**SUBDIVISION,  
PLANNED UNIT DEVELOPMENT,  
ZONING AMENDMENT, &  
SIDEWALK WAIVER STAFF REPORT****Date: January 7, 2016****APPLICANT NAME**

Coastal Ready Mix Development Subdivision

Subdivision Approval to create one legal lot of record from three metes-and-bounds parcels; Planned Unit Development to allow multiple buildings on a single building site; Rezoning from R-A, Residential-Agricultural District, to I-2, Heavy Industry District, to allow the construction of a concrete plant; and a Sidewalk Waiver approval to waive construction of sidewalks along Hamilton Boulevard.

# DETAIL SITE PLAN

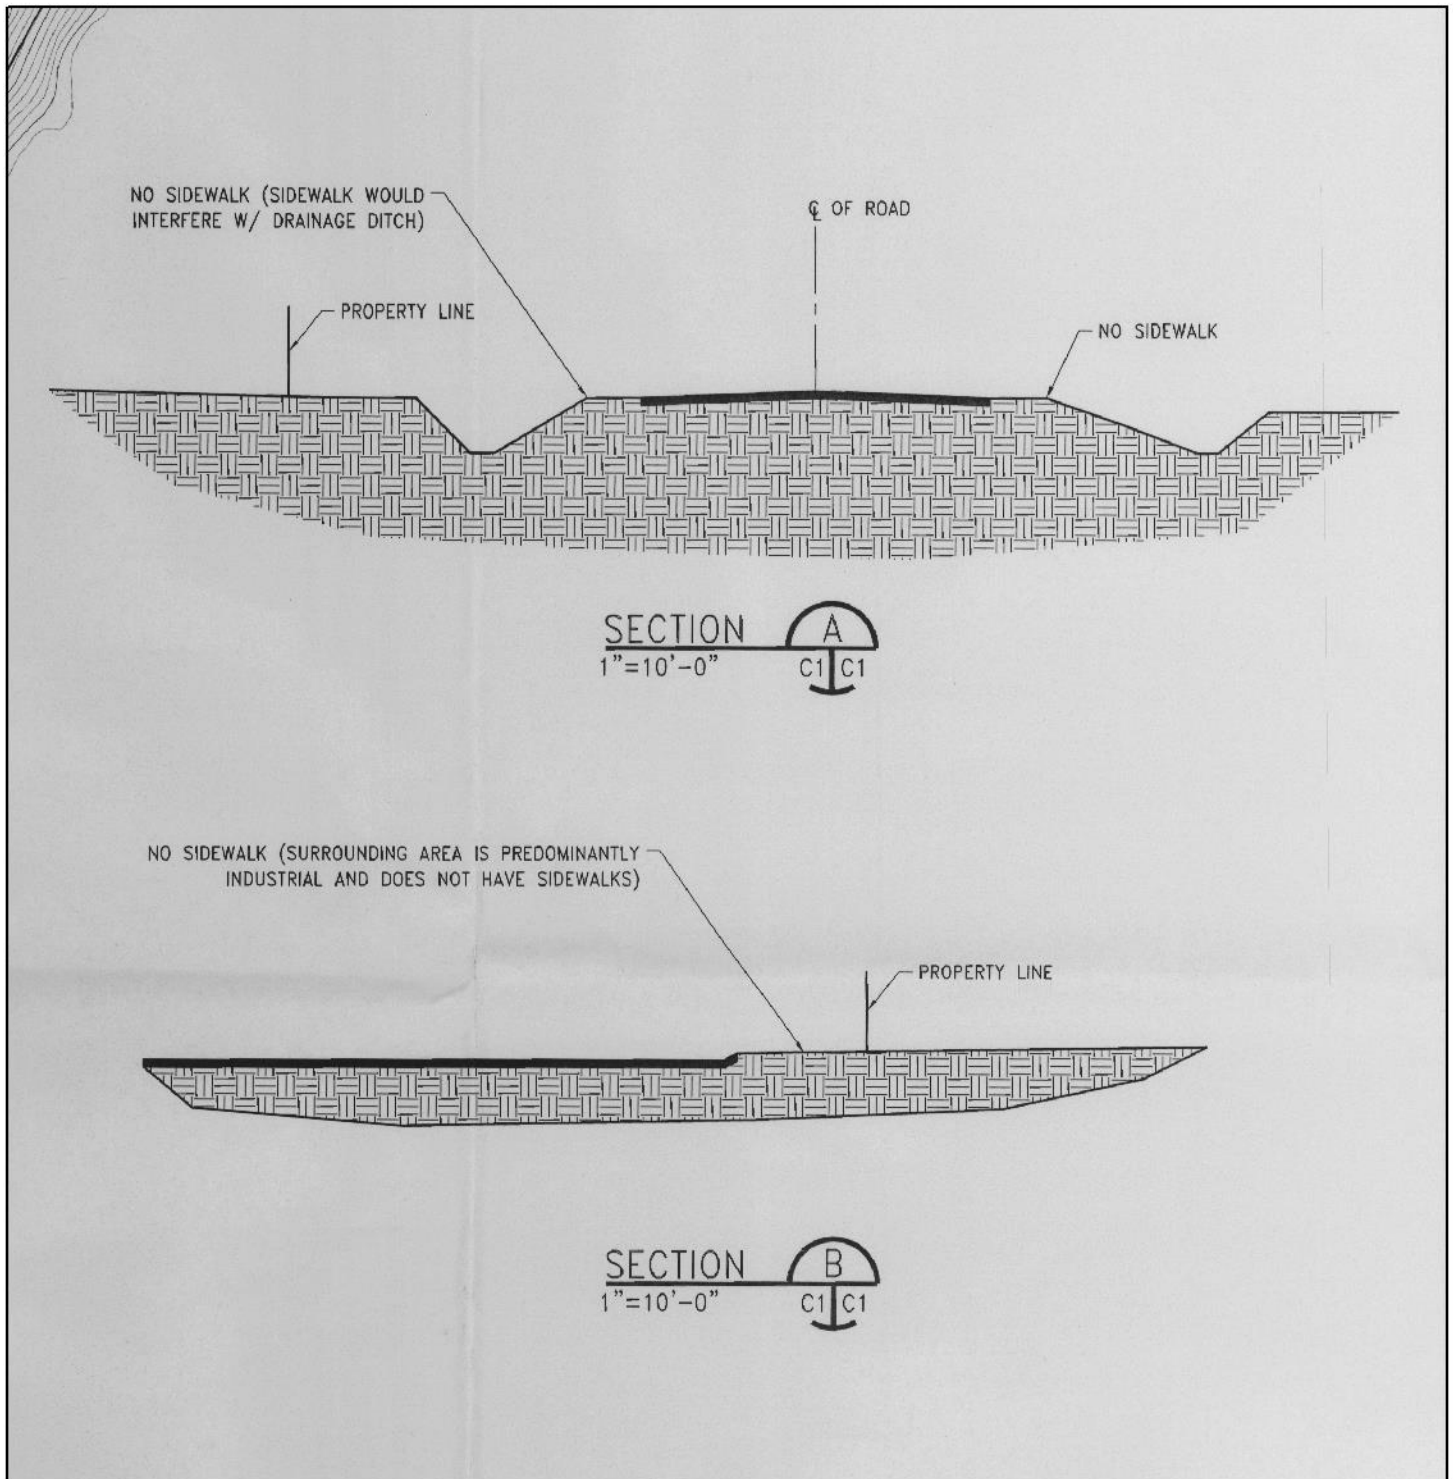
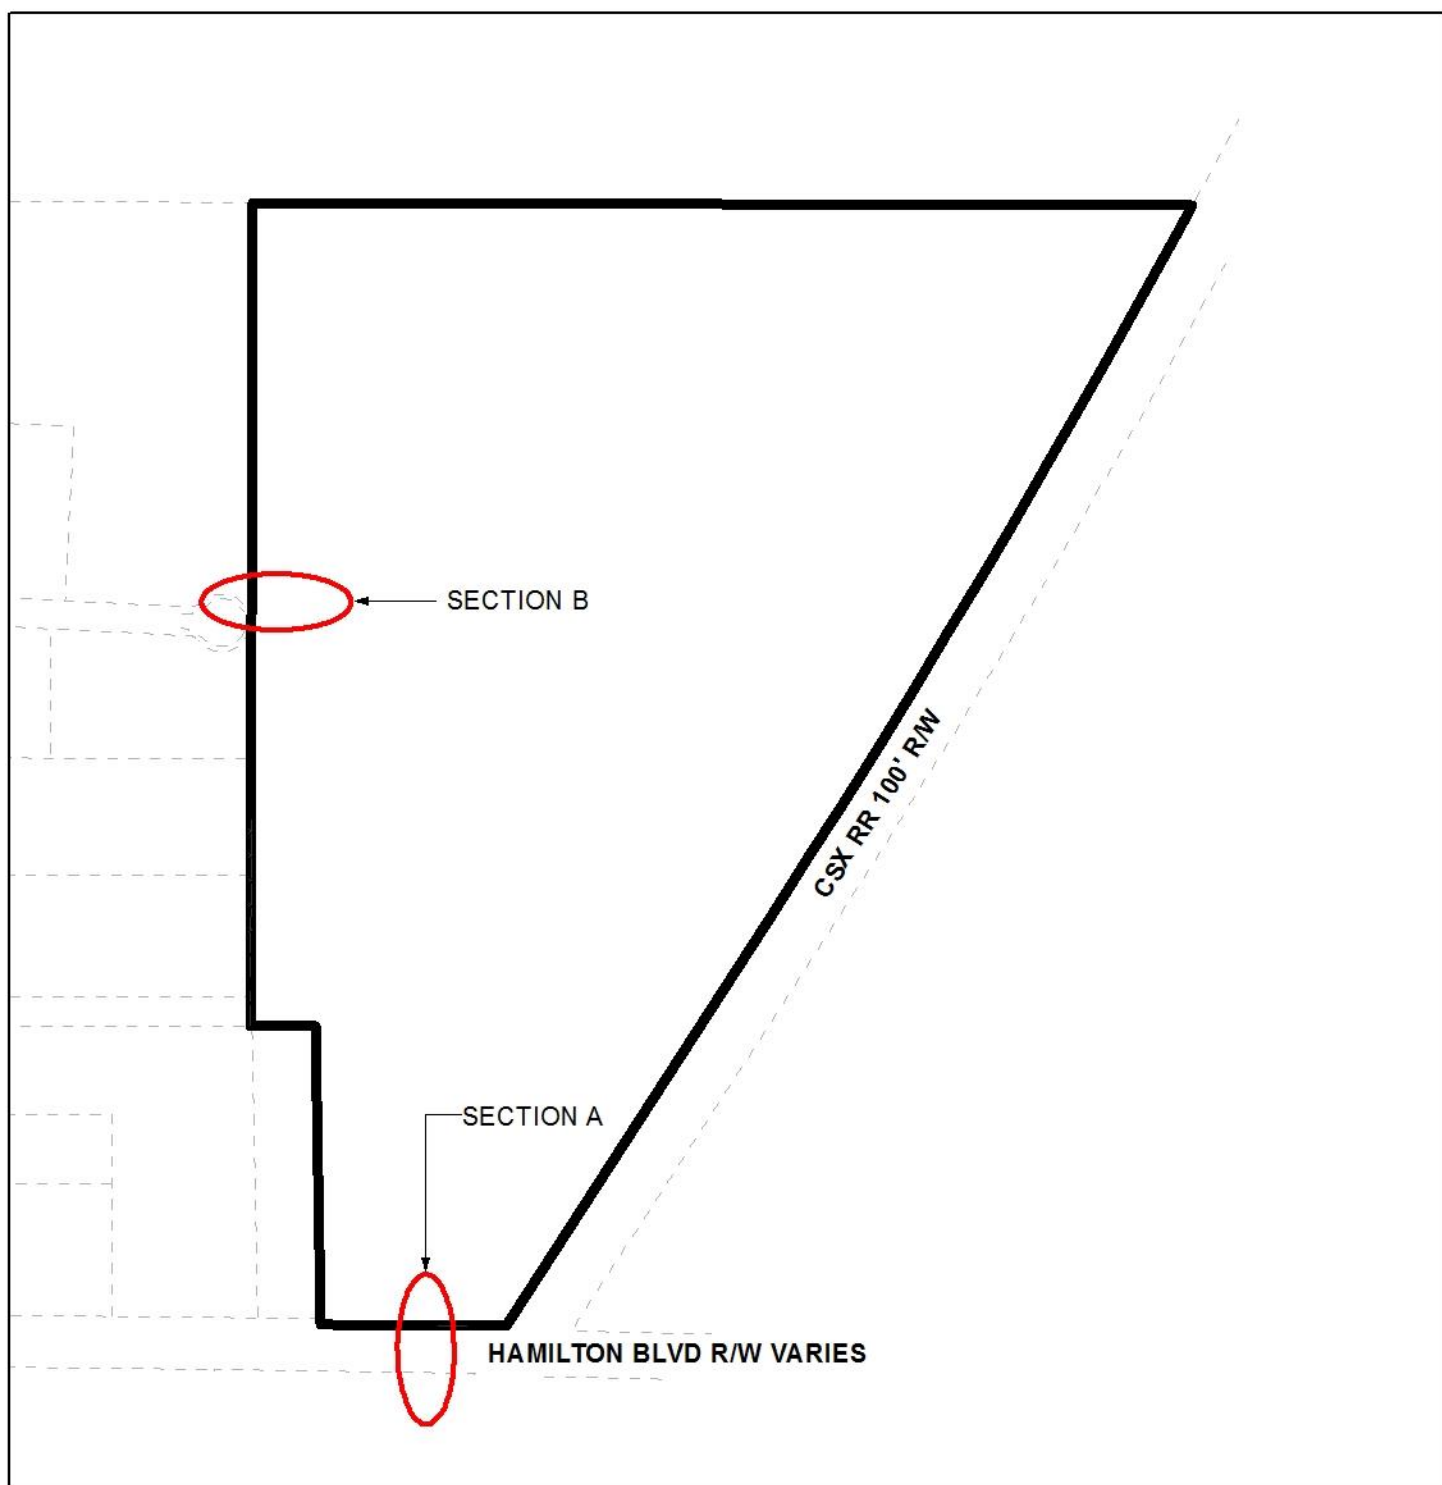
The site plan illustrates the proposed concrete batch plant; an employee parking lot with 30 parking spaces; a 10,000 gallon fuel tank; a “truck parking lot”; and “aggregate storage bins”. The site plan does not provide the square footage of office space nor the amount of warehouse employees to be at the site, therefore it is difficult for staff to determine if the 30 proposed parking spaces will be sufficient.

The site plan does not illustrate proposed tree plantings or provide landscaping data. It should be noted that full compliance with tree and landscaping requirements of the Zoning Ordinance will be required.

The proposed site plan does not indicate a dumpster on the site. If approved, the site plan should be revised to indicate either a dumpster connected to sanitary sewer and an enclosure in compliance with Section 64-4.D.9. of the Zoning Ordinance, or placement of a note stating that curb-side pickup will be utilized.

Because the site does have R-A, Residential Agricultural District to the North of the site, a residential buffer compliant with Section 64- 4.D.1. of the Zoning Ordinance should be provided. The site plan should be revised to reflect this requirement.

- 1) correctly label "East Rite Road";
- 2) revision of the site plan to indicate the square footage of office space to be provided on site as well as the number of warehouse employees and provision of parking calculations on the site plan per info provided;

- 3) revision of the site plan to indicate that the site will provide full compliance with landscaping and tree planting requirements of the Zoning Ordinance;

- 4) revision of the site plan to illustrate a residential buffer compliant with Section 64- 4.D.1. of the Zoning Ordinance to the North of the site;
- 5) revision of the site plan to indicate either a dumpster connected to sanitary sewer and an enclosure in compliance with Section 64-4.D.9. of the Zoning Ordinance, or placement of a note stating that curb-side pickup will be utilized;
